THE GLIDING FEDERATION OF AUSTRALIA

GFA AN 187

AIRWORTHINESS ADVICE NOTICE

TYPE AFFECTED: Arcus M

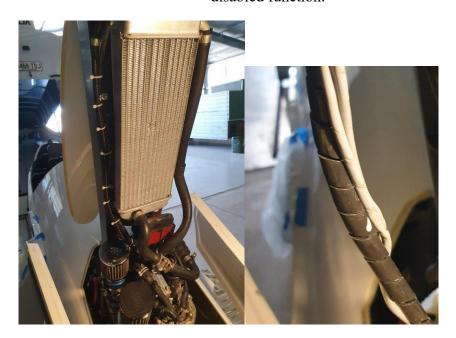
3. Throttle body aluminum rails fractured and replaced (reference Solo Service Bulletin Nr 4600-8). Vibration and mounting holes too close to edge of aluminum angle section caused the failure.

Rails replaced by composite material parts supplied by Schempp-Hirth from Solo. This required dismantling the unit in the engine bay and replacement / exchange with new parts. New engines do not require upgrade as have a modified throttle body unit.
